From: Tracey Carroll
Sent: Tuesday, December 11, 2012 9:58 AM
To: Heckman, Lee
Subject: CD-2012-0021 aka 211 S. Lamar Blvd.

File Number: CD-2012-0021

RE: 211 S. Lamar Blvd. Planned Unit Development Assessment;
Item 91 on Austin City Council's Agenda for December 13, 2012

211 South Lamar / C814-2012-0160 / Response to Update #1

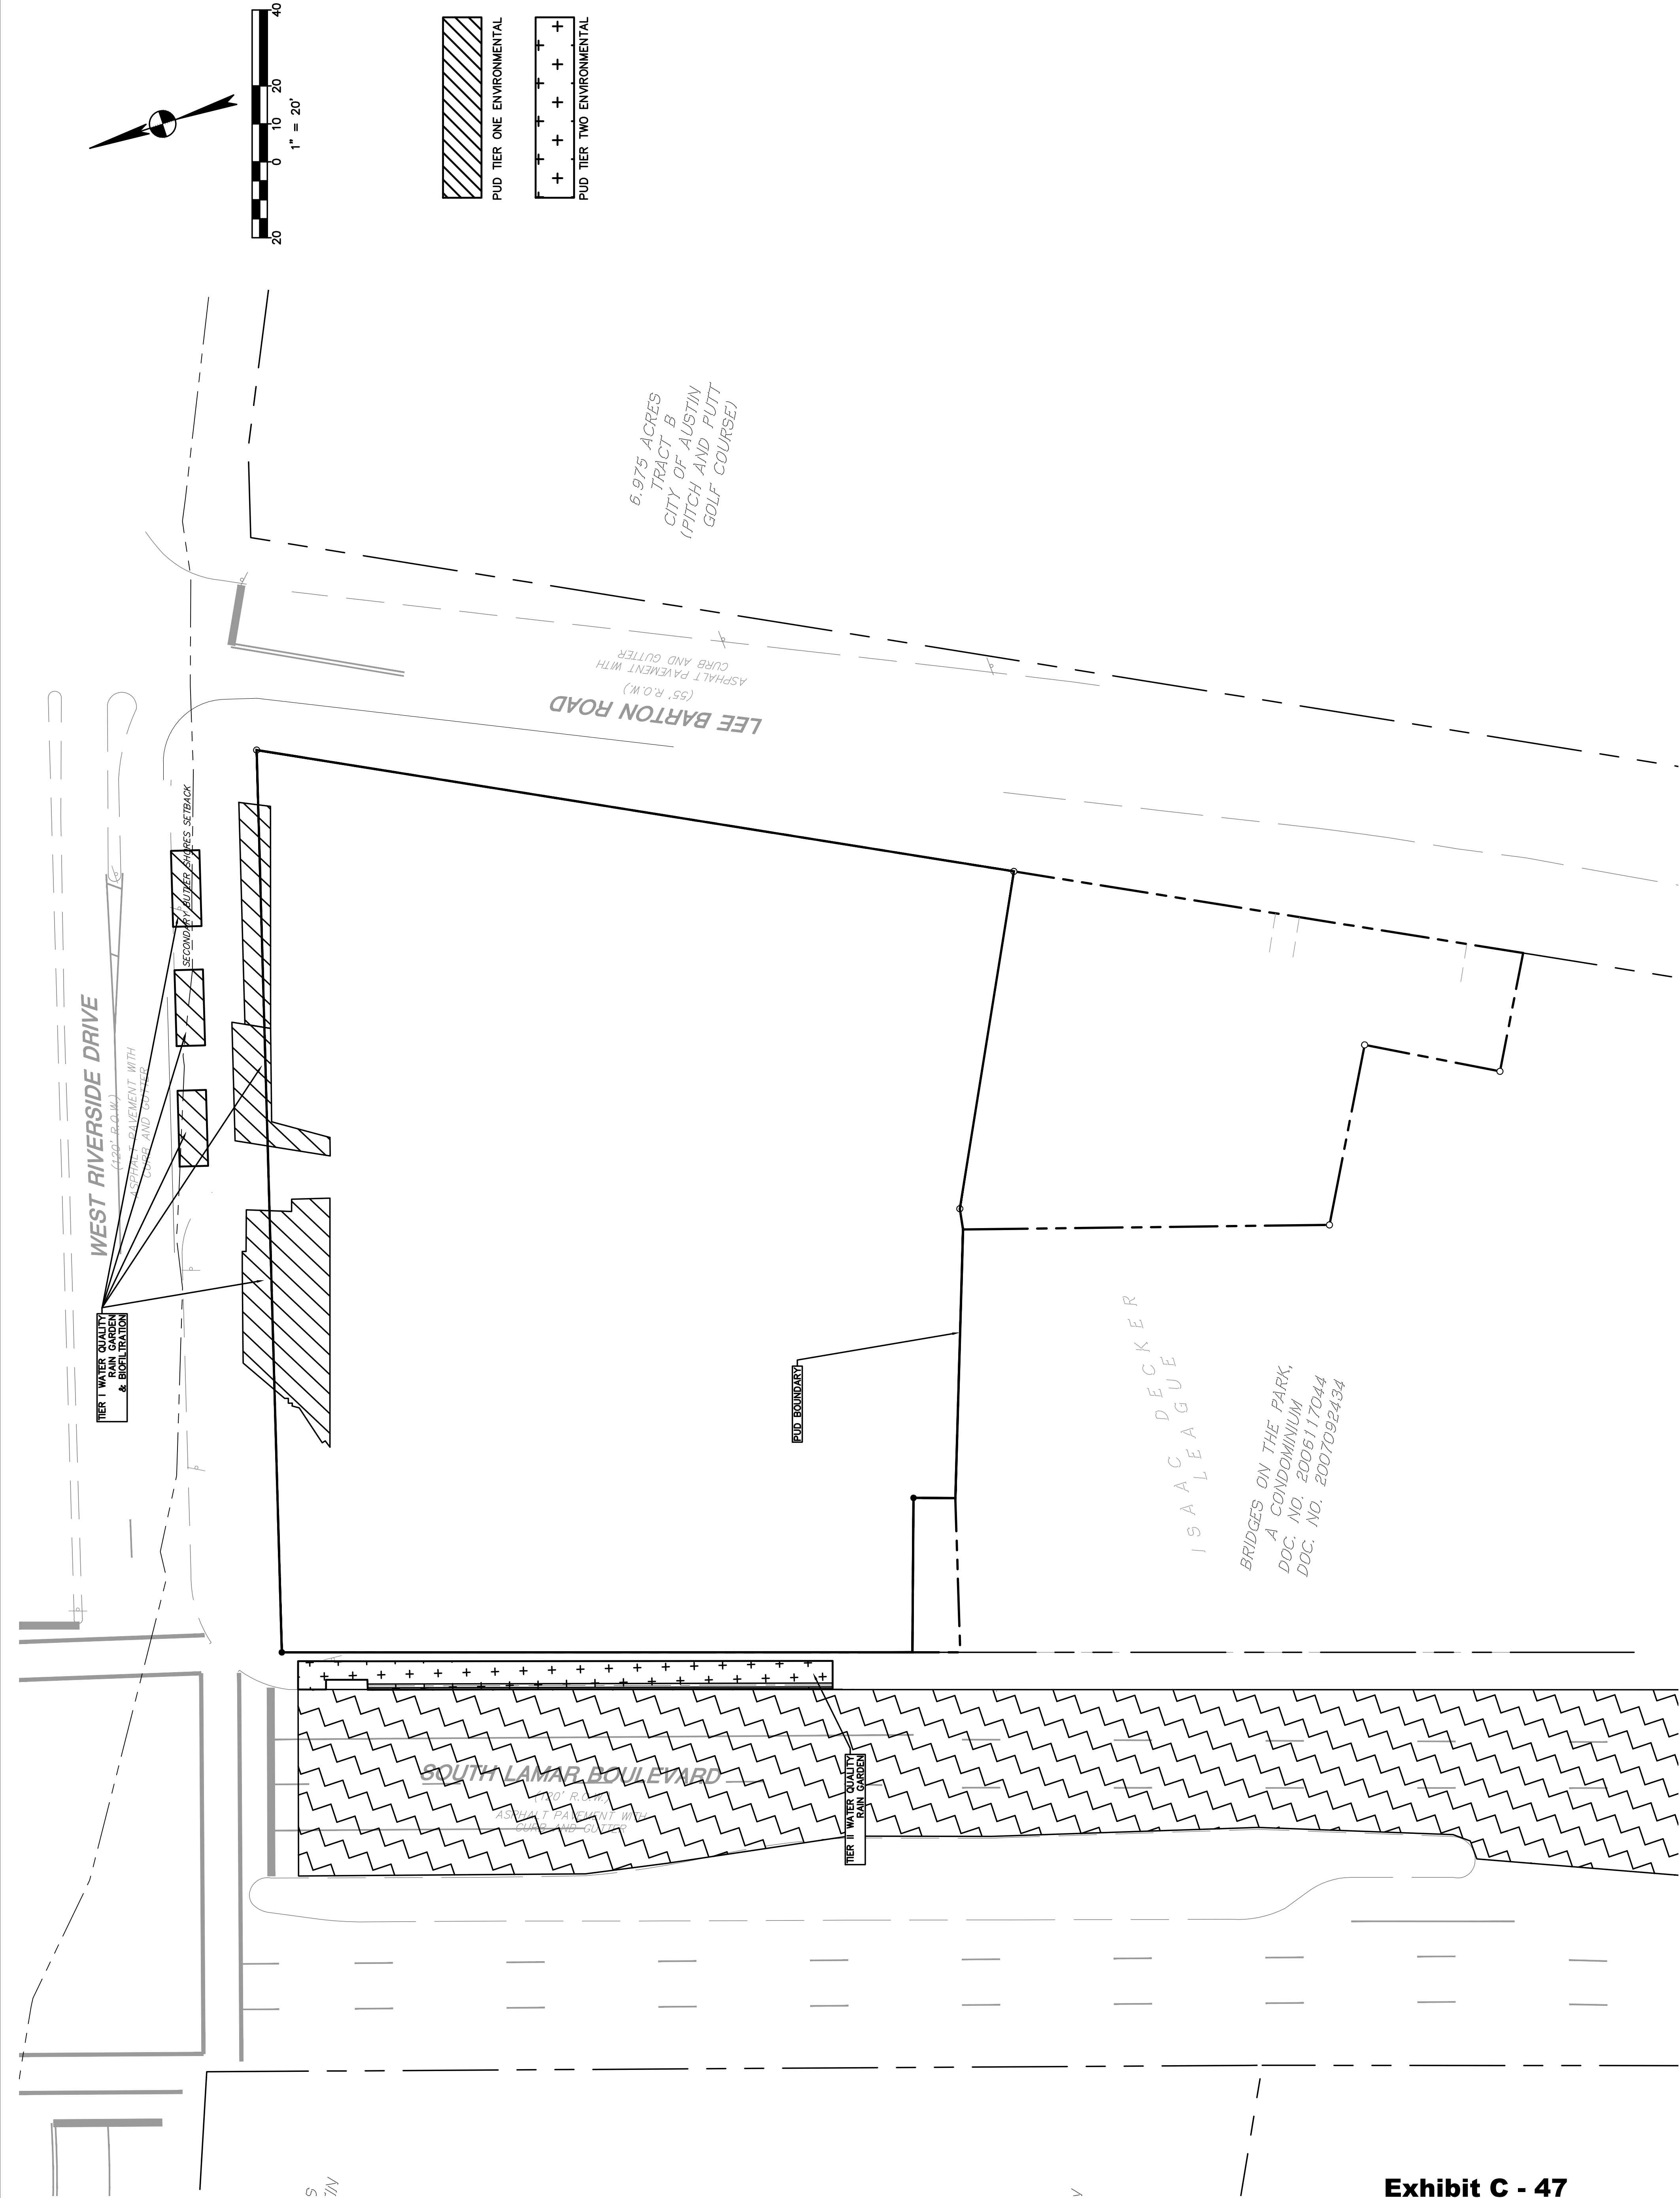
3. Land Use Plan Comments – Sheet 1

- h. Note # 32: Please highlight trees in Sheet 1 schematics. See also 6a, below.
- i. Note # 33/Variance to TCM9.3.0 #3: Is this a variance to zoning requirements or to site-planning requirements? If it is appropriate to consider at the rezoning stage, then provide the documentation from Transportation (see reviewer note #7) concurring with the proposal. If this is NOT a variance to the zoning code, but associated with site-planning, then please remove from plan sheet and table of CS variances.

- g. **Noted.**
- h. Note # 32: Please highlight trees in Sheet 1 schematics. See also 6a, below.
- h. **A new sheet has been added to the Land Use Plan clarifying tree preservation.**
